**CODE MODIFICATION REQUEST**  
(COMMERCIAL)

BUILDING/STRUCTURE NAME: Paragon Star – Building 2 Shell

PERMIT NUMBER (if applicable): PRCOM20192646

**EXHIBIT A** (mixed-use building completed in 2020 in Lenexa, KS):

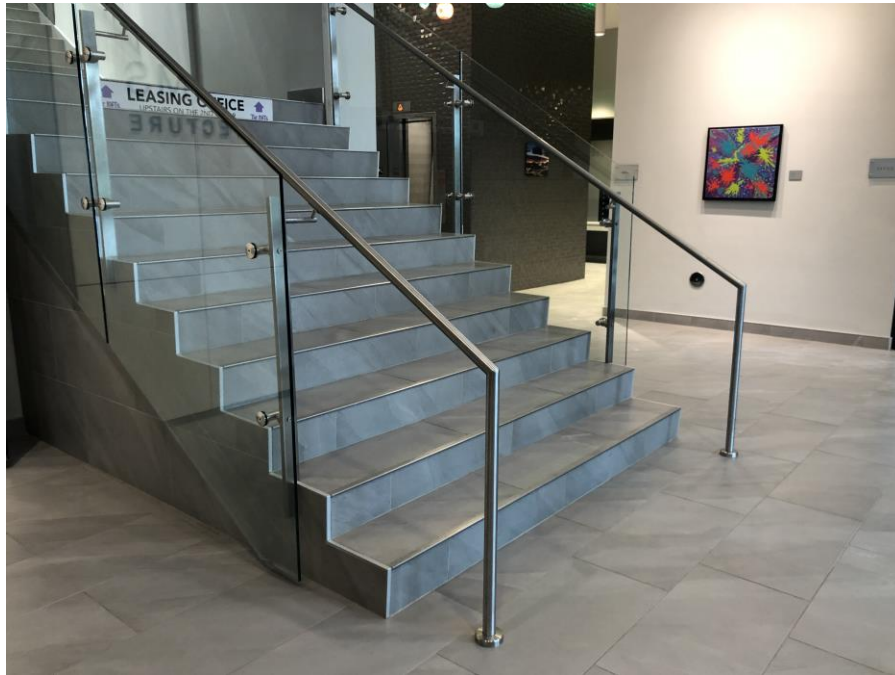
Our request is for an alternate interpretation of 2018 IBC 1015.2 Guardrail Height. Guardrails are required to prevent falls from 30" or more above the adjacent floor surface. The guardrails shown on Sheets A6.02 and A6.03 start no more than 12" above the adjacent floor surface. We've included images of stairs recently constructed in other local jurisdictions that have a similar guardrail detail (see Exhibits A and B). We have also included an excerpt from the ICC Code Commentary for 2018 IBC 1015.2 (Exhibit C). We have also included an official code interpretation from the ICC (Exhibit D) supporting our request.
